DISD Leila P Cowart Elementary School
DISD James Bowie Elementary School
COMM. NO. 1287 and 1288
ORG 130 and 112
CSP J130_P1000_1 and J112_P1000_1 (207858)
January 28, 2025

ADDENDUM NO. 01
TO THE DRAWINGS AND PROJECT MANUAL

6 TYPICAL CONCRETE WALK DETAIL 1" = 1'-0"

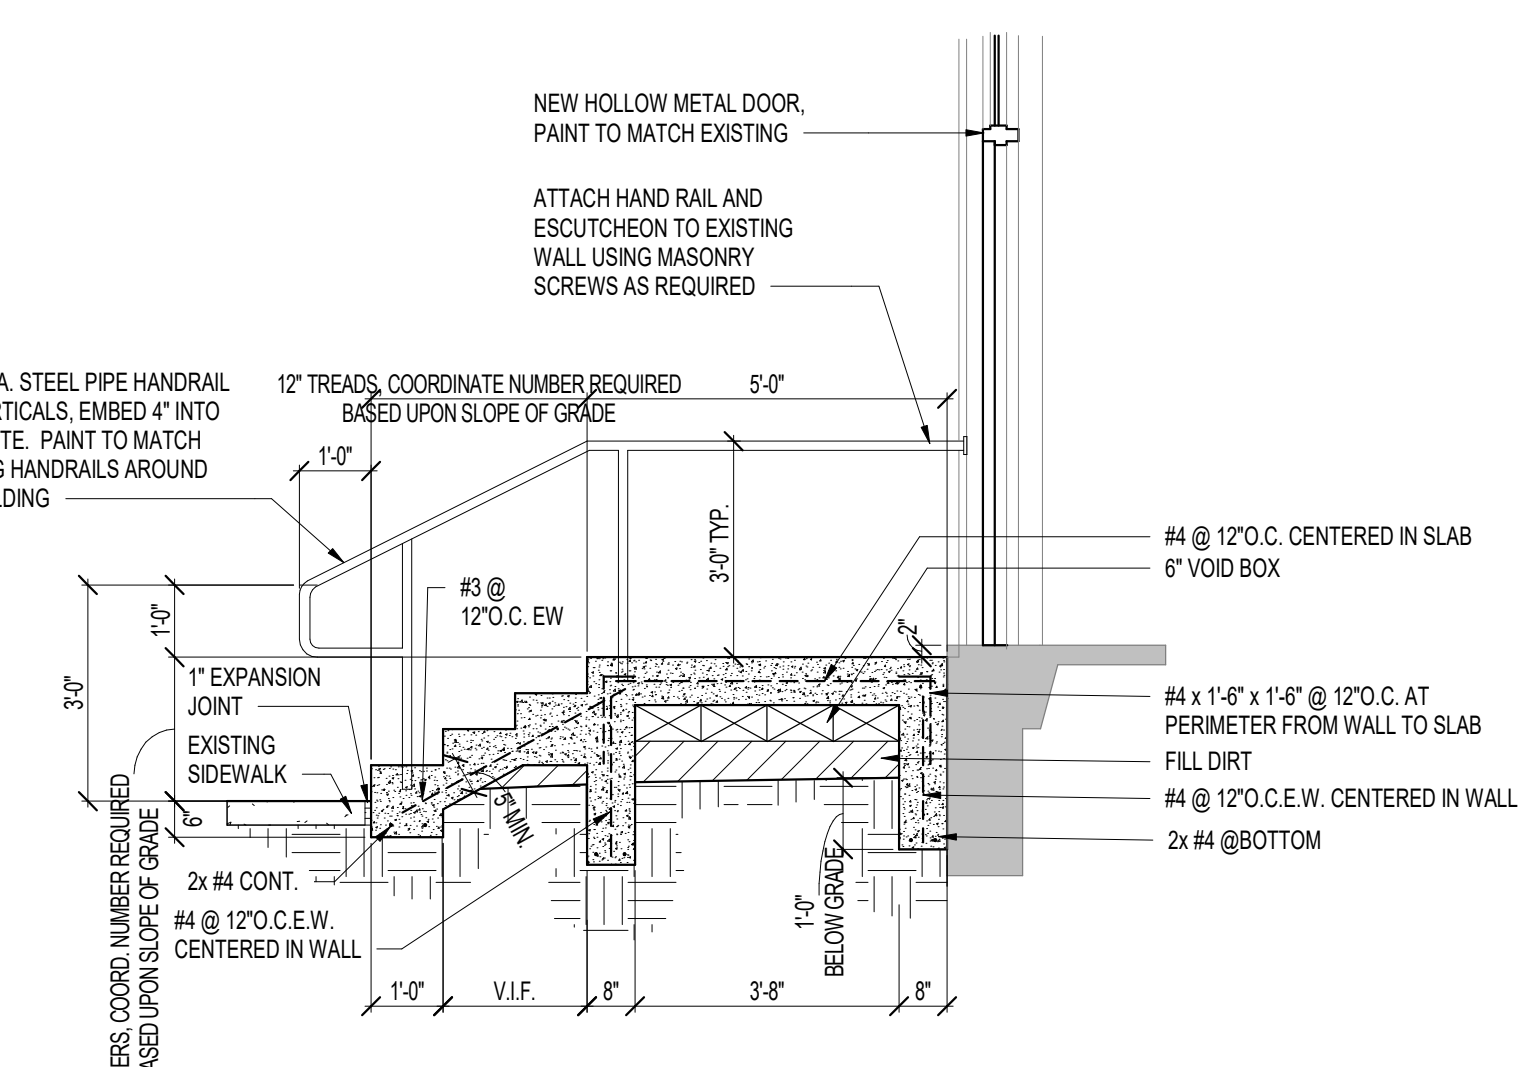
- 1.07 Leila Cowart: Replace existing sheet 1.01 SITE PLAN with new sheet 1.01 SITE PLAN dated 1-27-25 showing an added detail 06 TYPICAL CONCRETE WALK DETAIL.
- 1.08 Leila Cowart: Replace existing sheet 2.17A DEMOLITION ROOF PLAN – AREA D with new sheet 2.17A DEMOLITION ROOF PLAN – AREA D dated 1-27-25 showing DEMOLITION ROOF PLAN NOTES BY NUMBER relocated for clarity.
- 1.09 James Bowie: Replace existing 4.04A SIGNAGE PLAN – LEVEL 01 with new sheet 4.04A SIGNAGE PLAN – LEVEL 01 1-28-25 showing alterations to SIGNAGE SCHEDULE – LEVEL 01.

1 SIGNAGE PLAN SECOND FLOOR
 1/16" = 1'-0"
 NORTH

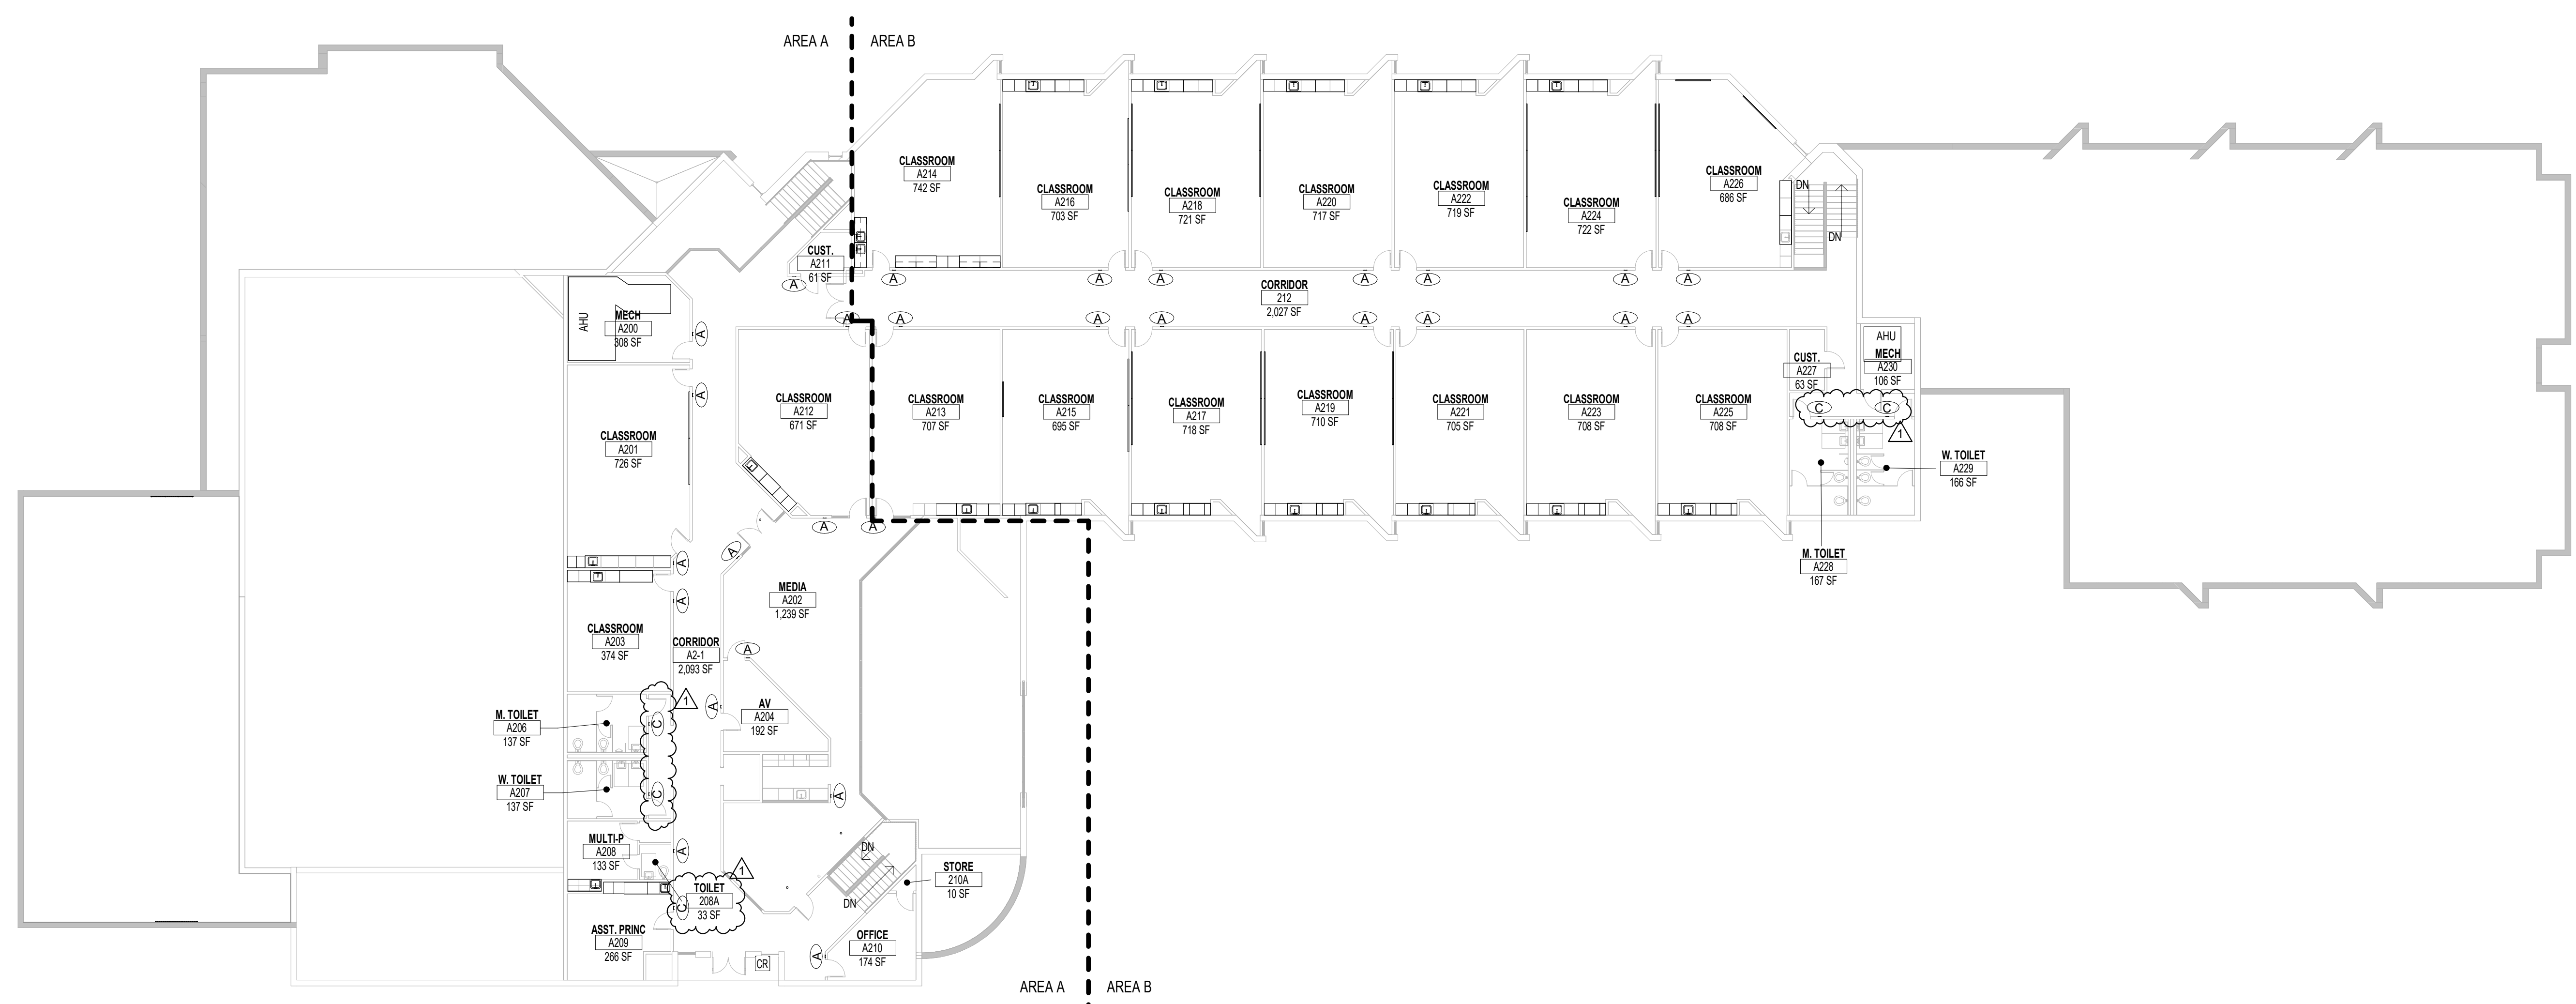
- 1.10 James Bowie: Replace existing 4.04B SIGNAGE PLAN – LEVEL 02 with new sheet 4.04B SIGNAGE PLAN – LEVEL 02 1-28-25 showing alterations to SIGNAGE SCHEDULE – LEVEL 02.
- 1.11 James Bowie: Replace existing QF121 FOOD SERVICE PLUMBING REQUIREMENTS PLAN with new sheet QF121 FOOD SERVICE PLUMBING REQUIREMENTS PLAN 02 1-27-25 showing a note moved for clarification.
- 1.12 James Bowie: Replace existing QF131 FOOD SERVICE VENTILATION & FLOOR DEP. REQUIREMENTS PLAN with new sheet QF131 FOOD SERVICE VENTILATION & FLOOR DEP. REQUIREMENTS PLAN 02 1-27-25 showing a note moved for clarification.

1 FOODSERVICE PLUMBING REQUIREMENTS PLAN QF121 SCALE: 1/4" = 1'-0"

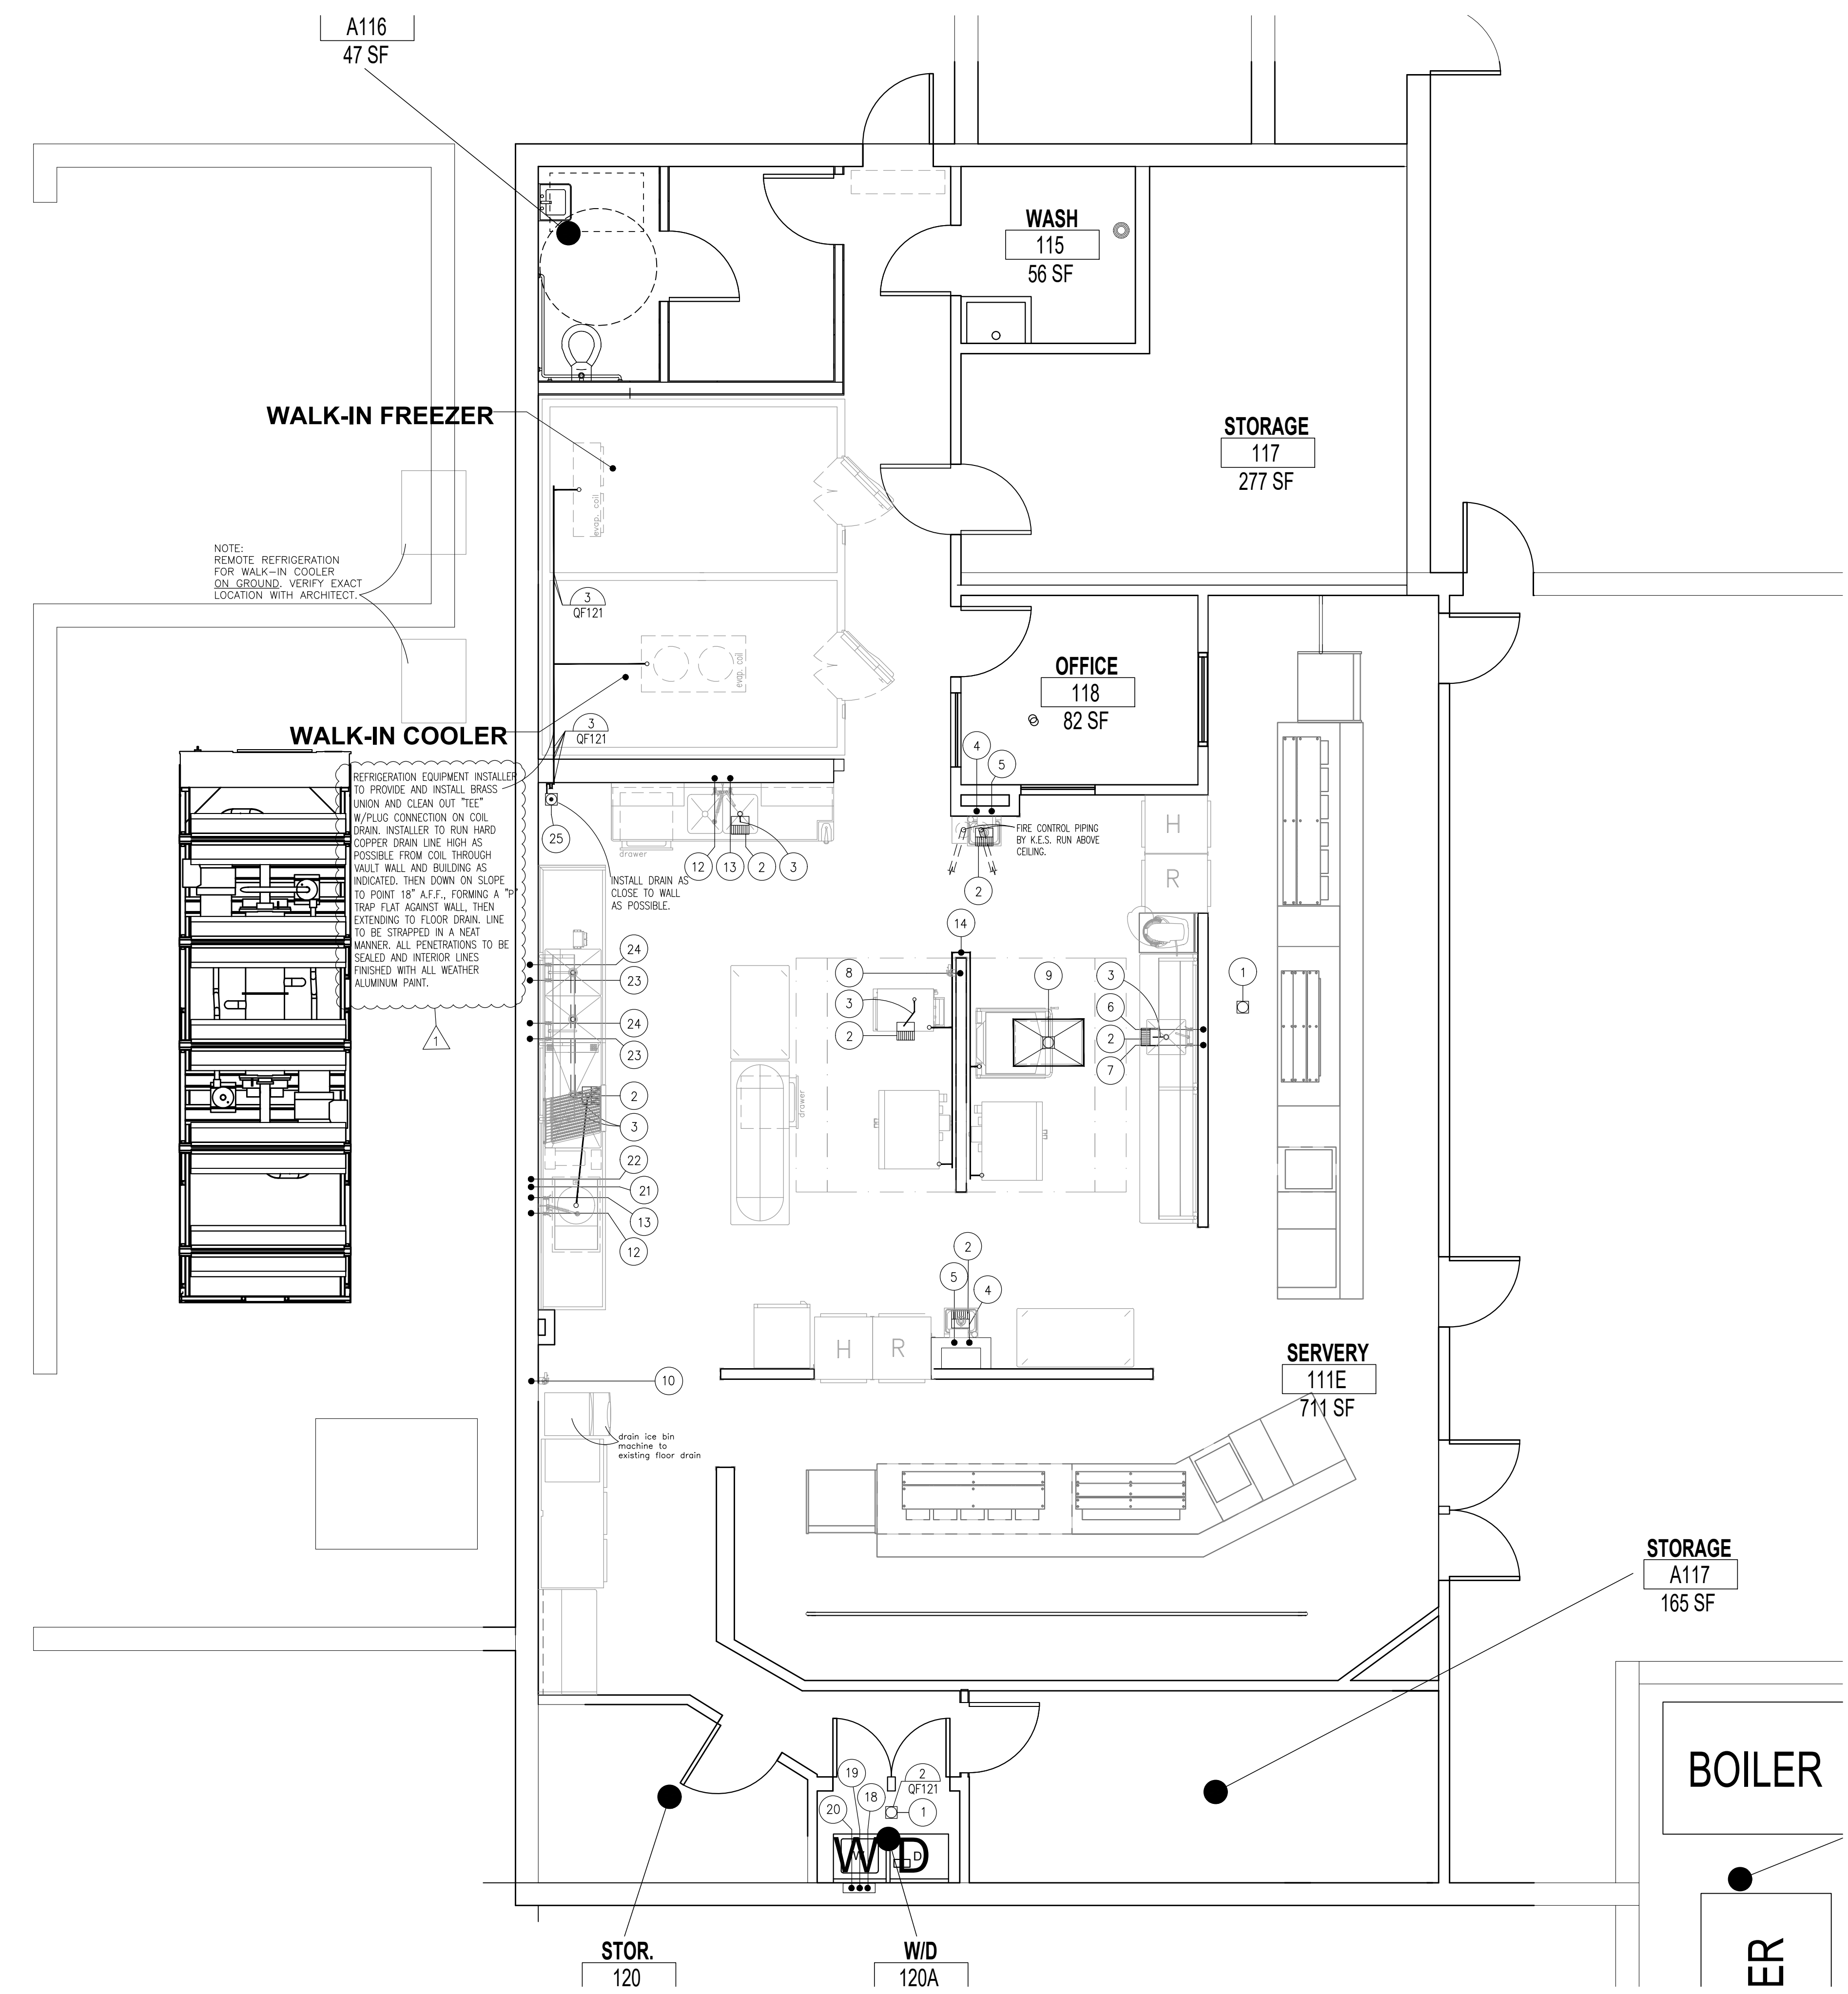
- 1.01 Combined Specifications: "Please provide the available existing swing space"
RESPONSE: None is available. See attached replacement specification section 01 52 14 Temporary Facilities For Students.
- 1.02 Leila Cowart: "Please provide detail for sidewalk replacement"
RESPONSE: Detail added, see attached sheet 1.01.
- 1.03 Leila Cowart: "Please move note so it can be read"
RESPONSE: Note moved, see attached sheet 2.17A.
- 1.04 James Bowie: "Signage Schedule is incomplete. Can we get a complete schedule?"
RESPONSE: Signage Schedule has been filled-in. See attached sheets 4.04A and 4.04B.
- 1.05 James Bowie: "Note is hard to read due to background. Can you move note?"
Response: Note moved, see attached sheets QF121 and QF131.
